**University Village North, Sections 3 & 4 - Revised  
PRELIM PLAT PP1510-001**

**University Village North, Sections 3 & 4  
PRELIMINARY PLAT PP1510-001**

**DATE OF REVIEW:** November 4, 2015

# UNIVERSITY VILLAGE NORTH - SECTIONS 3 & 4

PRELIMINARY PLAT OF UNIVERSITY VILLAGE NORTH - SECTIONS 3 & 4 SURVEY JOB NO. 50885-01

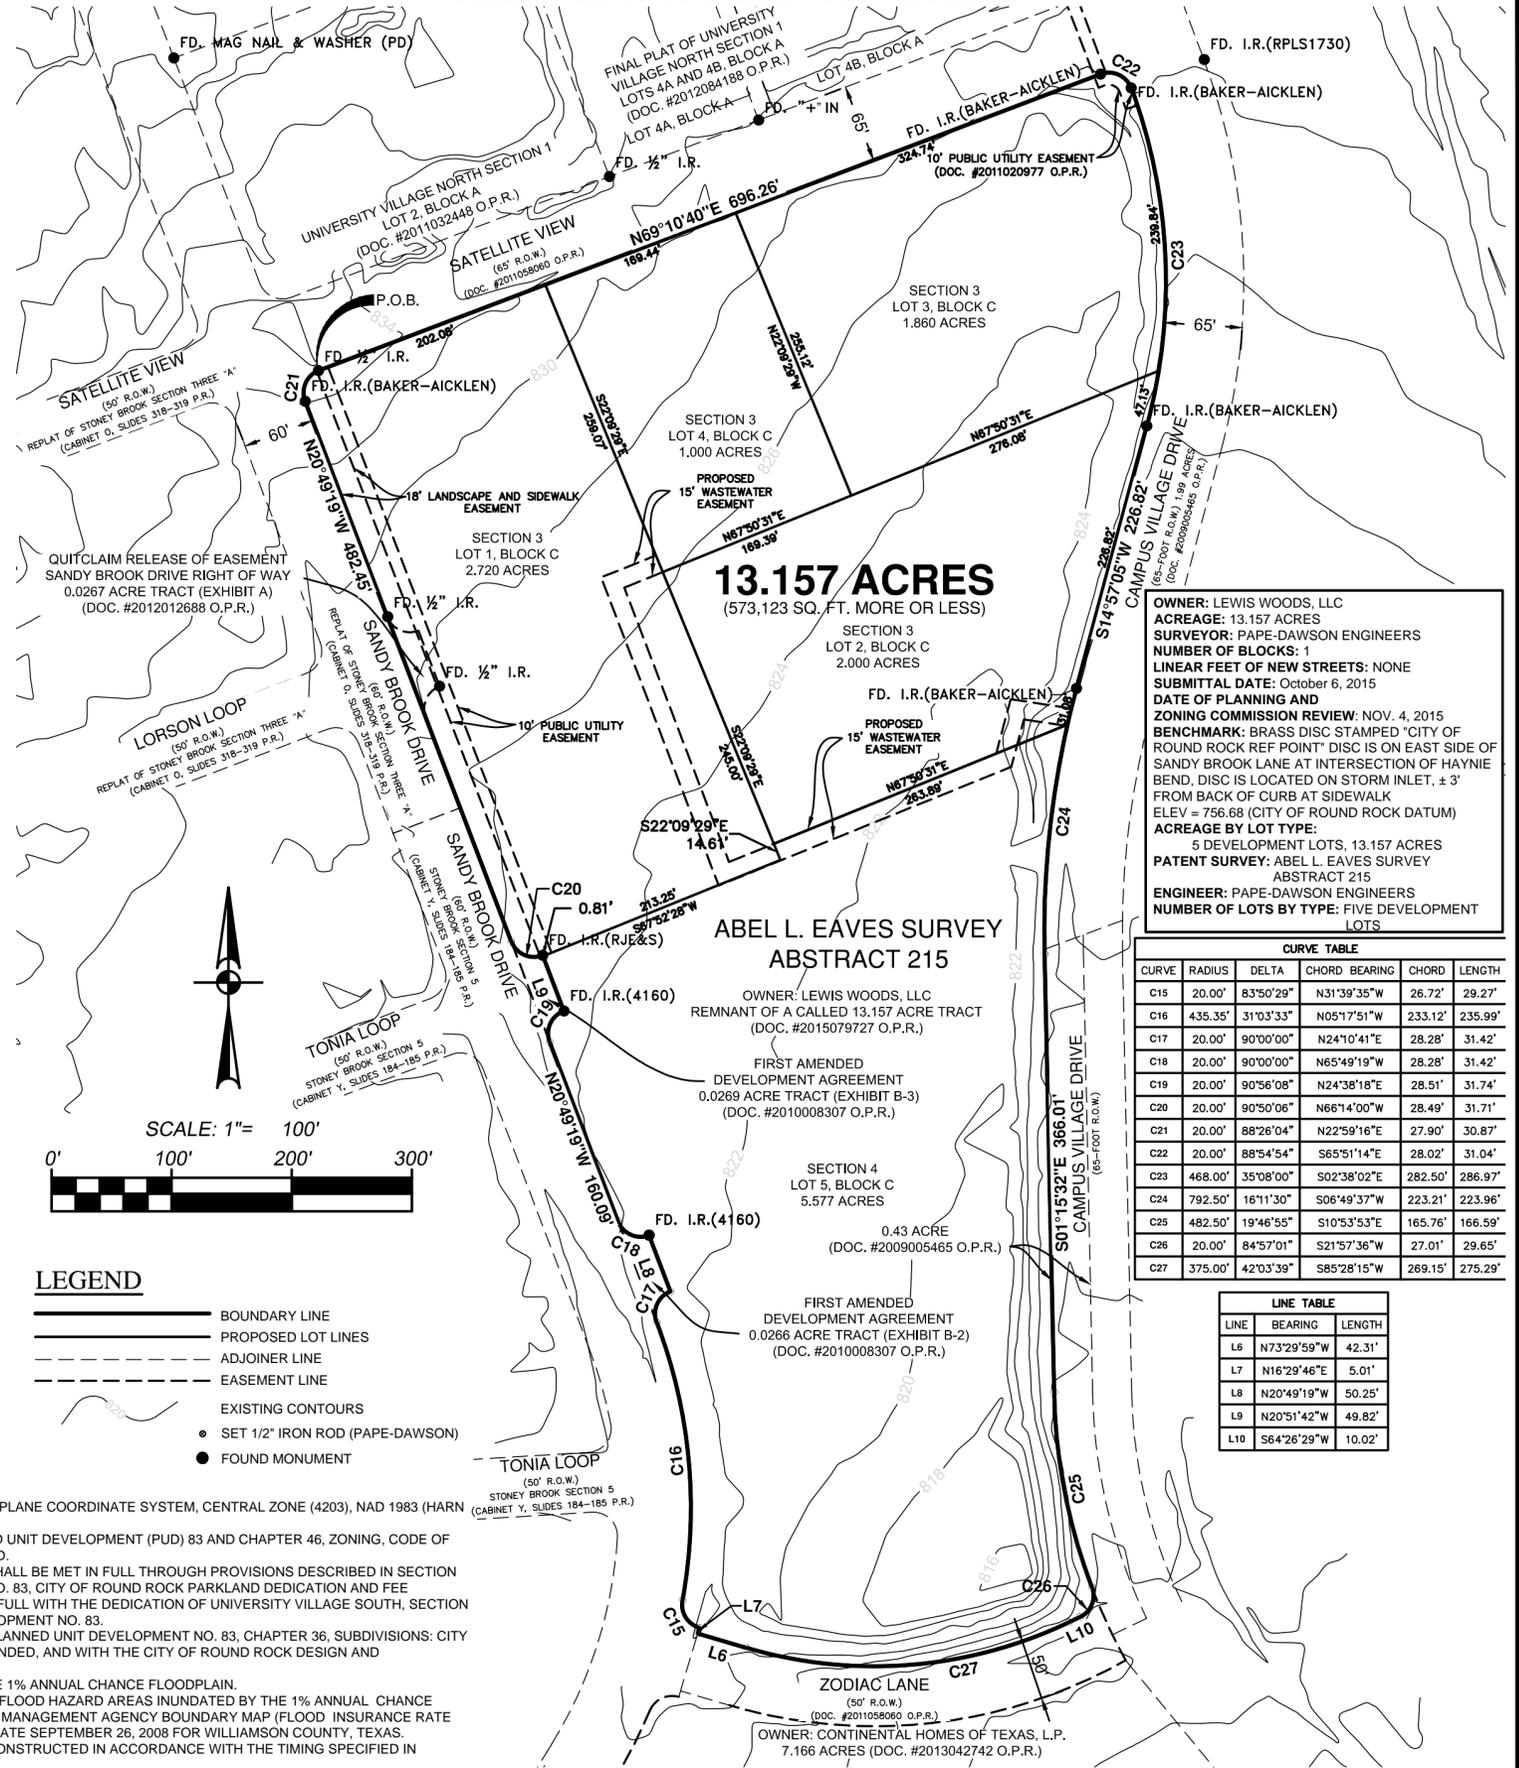
1. Provide vertical datum for the benchmark.
2. Update utility schematic to show services to all lots.
3. Correct typos in the general notes.
4. Remove both stub-outs along Sandy Brook Drive after the quitclaim release of easement has been recorded.
